SUBJECT: Responds to A Schwencer 790530 ltr requesting addl info re
 spend fuel storage capacity extension program. Submits
 revised pages to 781122 ltr re refined dimension of spent
 fuel rack storage cells.

Donald C. Cook Nuclear Plant Unit Nos. 1 and 2
Docket Nos. 50-315 and 50-316
License Nos. DPR-58 and DPR-74
Spent Fuel Storage Capacity Expansion Program

ATTACHMENT 1

FIGURE 3.6.6
PLAN

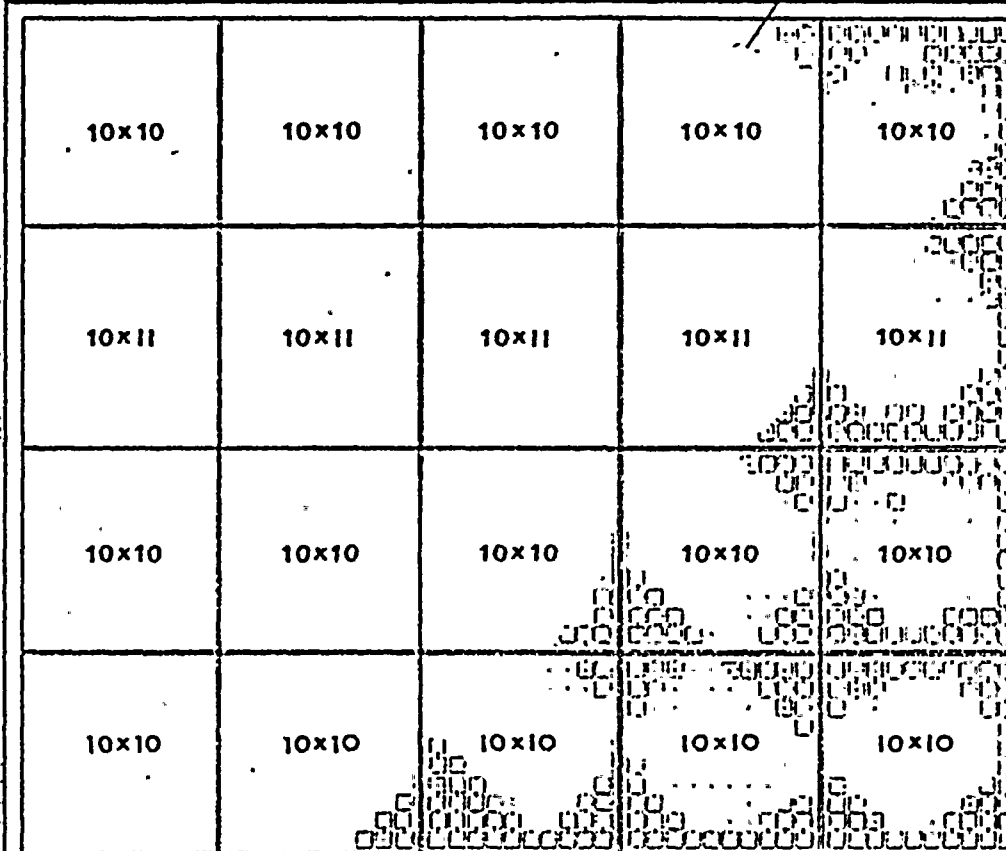
Provide the number of modules and the size of each module to be installed in the spent fuel pool. Include a drawing showing the arrangement of the racks in the pool.

Twenty modules will be installed in the spent fuel pool as follows:

- 15 - 10x10 array - 15' 4" high, 9' 1" square,
- 5 - 10x11 array - 15' 4" high, 9' 1" wide,
9' 11" long.

Figure 3.6.6 shows the arrangement of the racks in the pool.

FIGURE 3.6.7

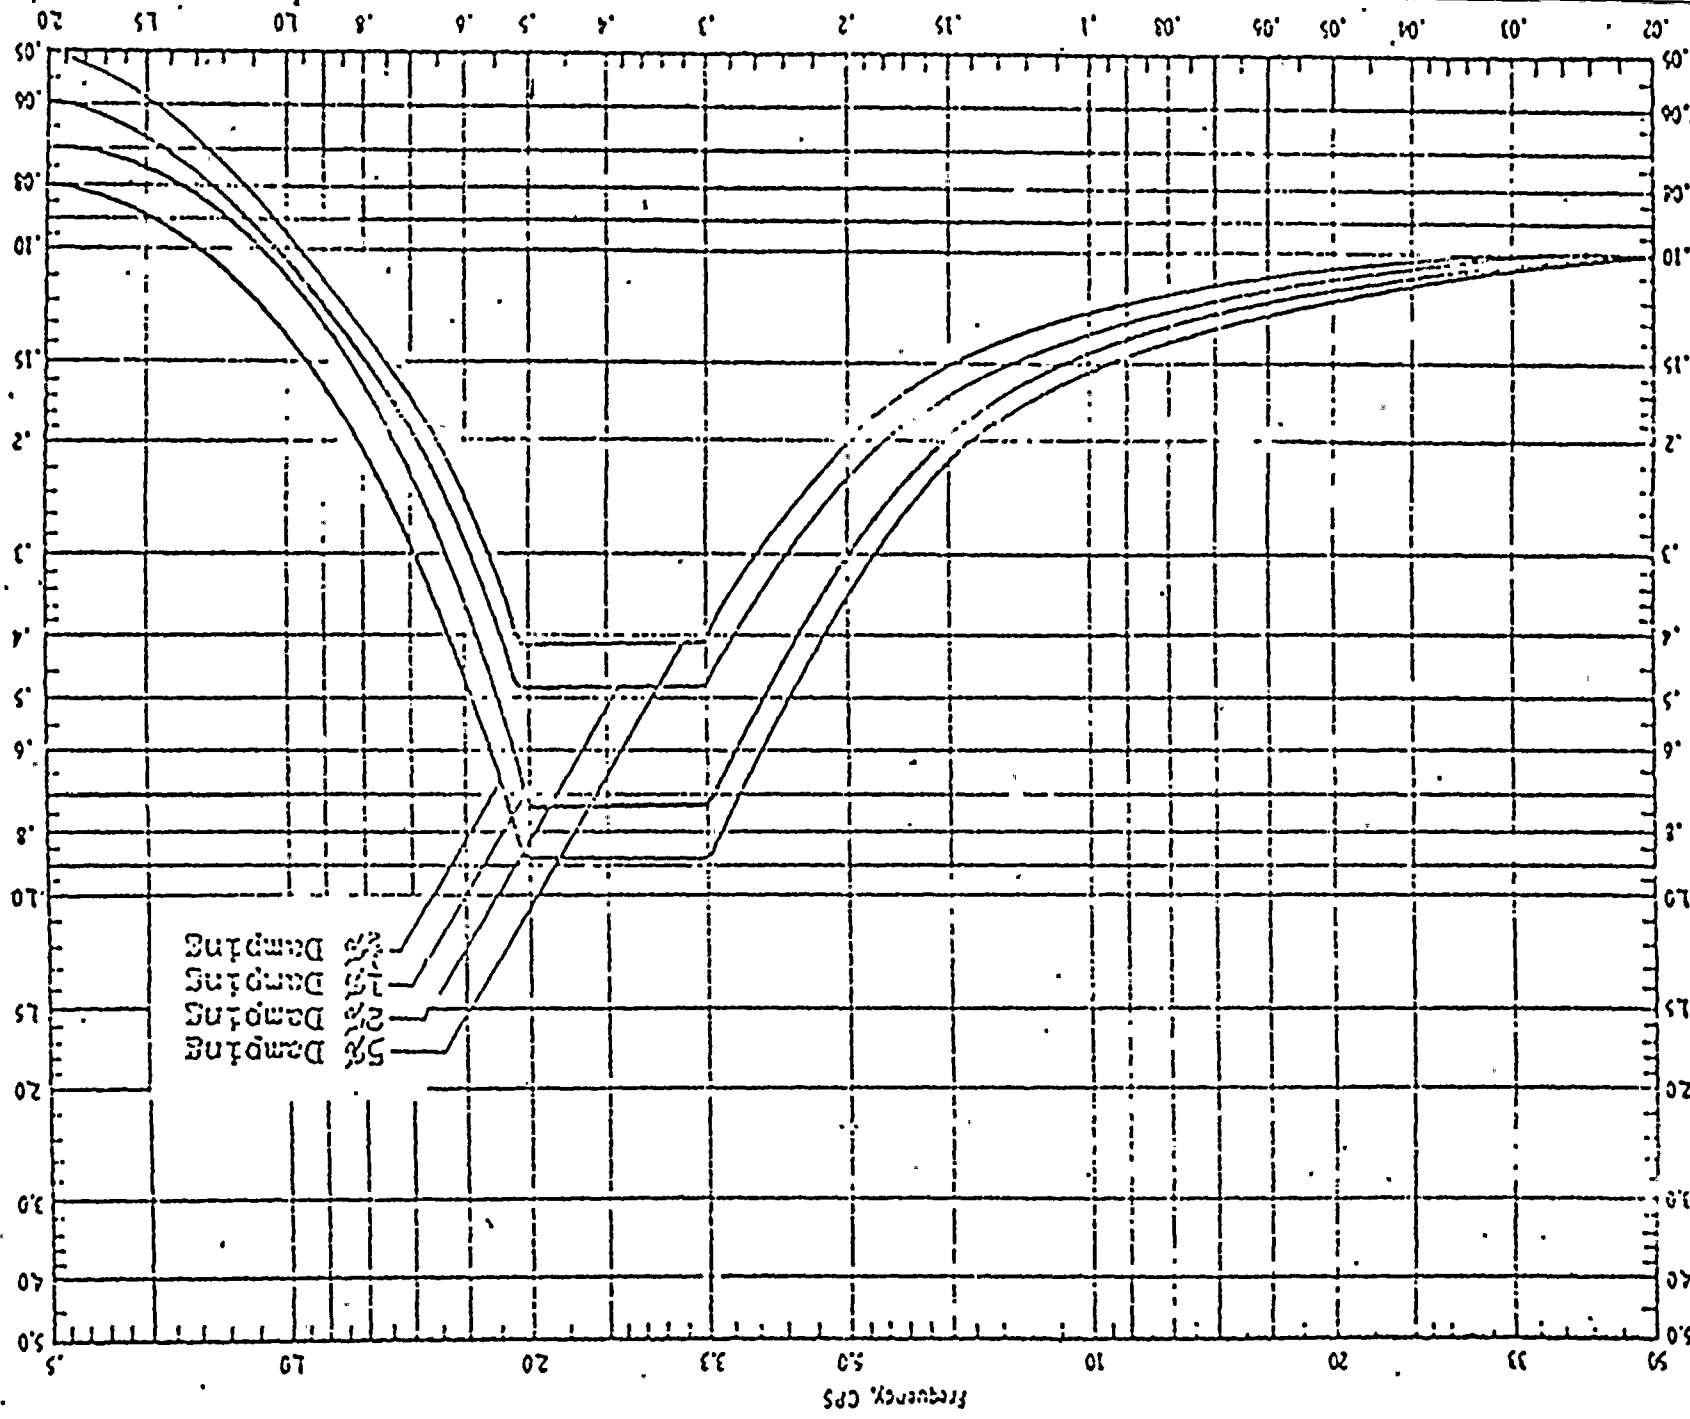
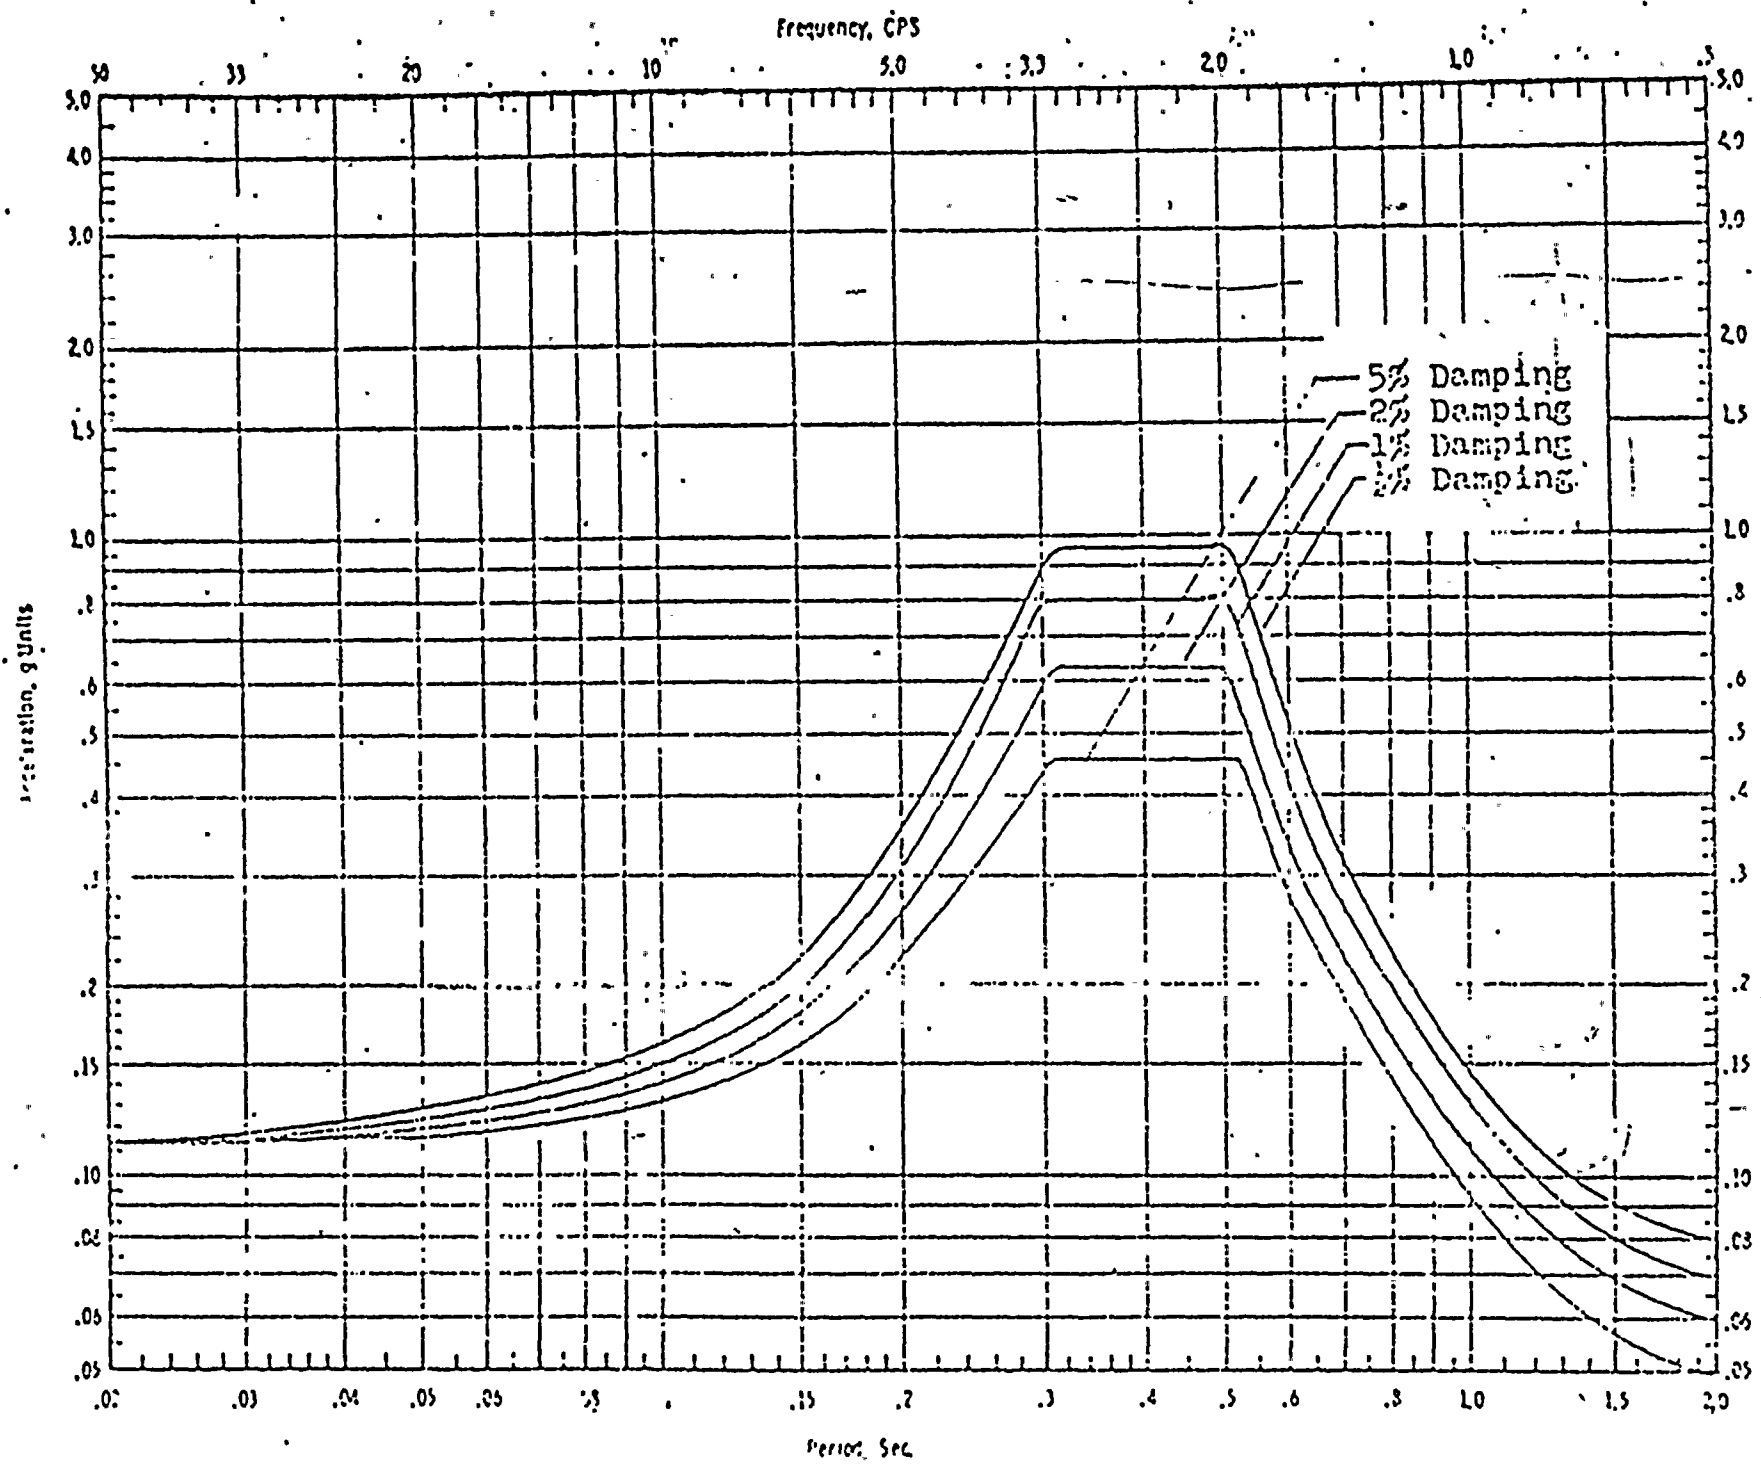
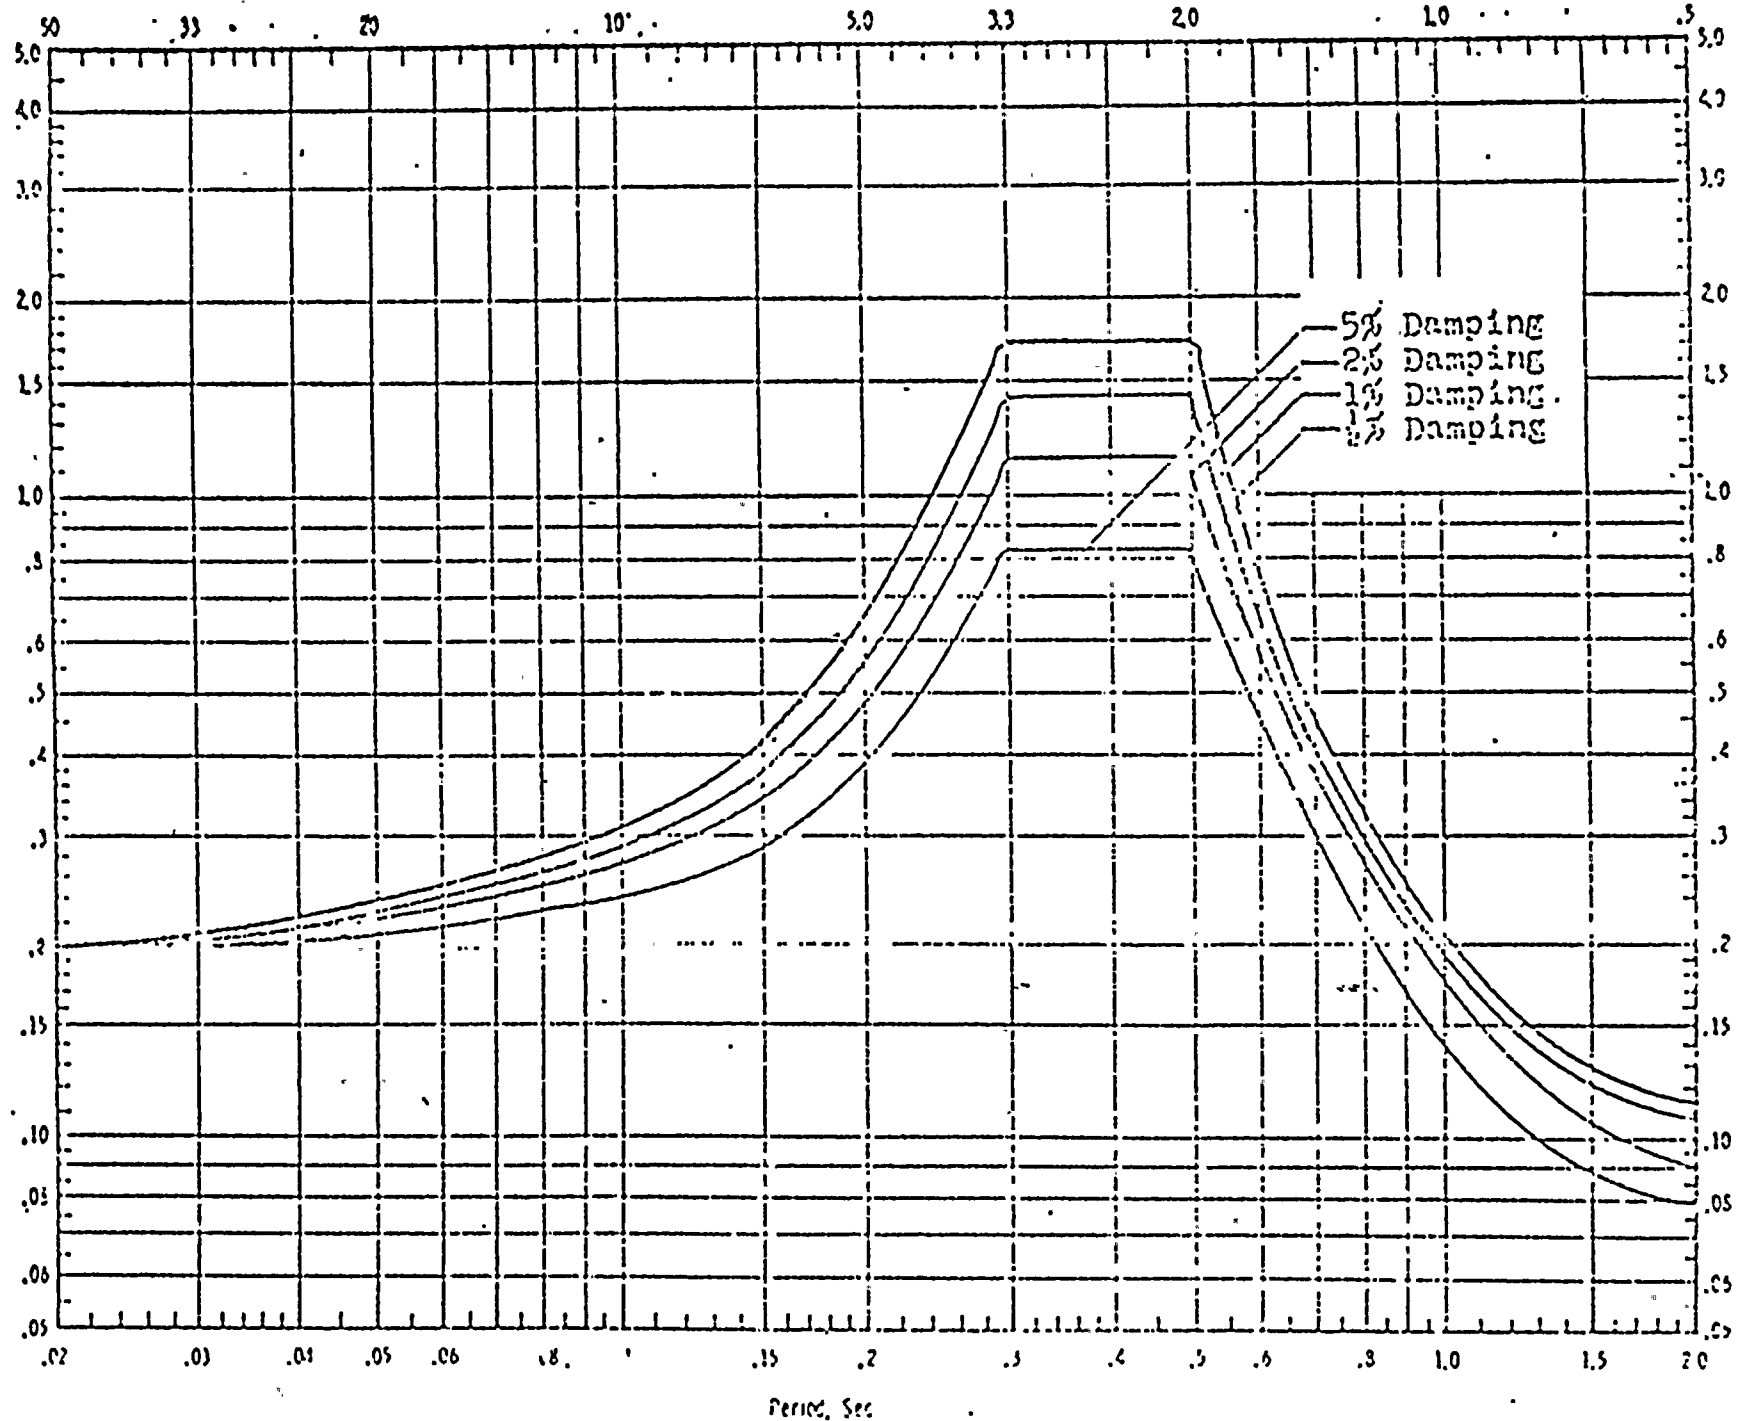
Provide details of the artificial time history showing a Fourier decomposition including a phase angle plot. Also, specify which floor response spectra was used in the analysis.

The floor response spectra used in the structural analysis is given in our submittal of April 16, 1979 Section 3.6.4.1 (sixth paragraph). For clarification the fuel pool floor response spectrum at El. 606' - 2½" was obtained by linear interpolation of the response spectra at El. 587' - 0" and El. 633' - 0". These floor response spectra were submitted to the NRC in Attachment IV of the response to the Seismic Qualification Review Team dated November 17, 1977, Docket No. 50-316, CPPR No. 61. Figures 3.6.7 through 3.6.10 are the floor response spectra used for interpolation.
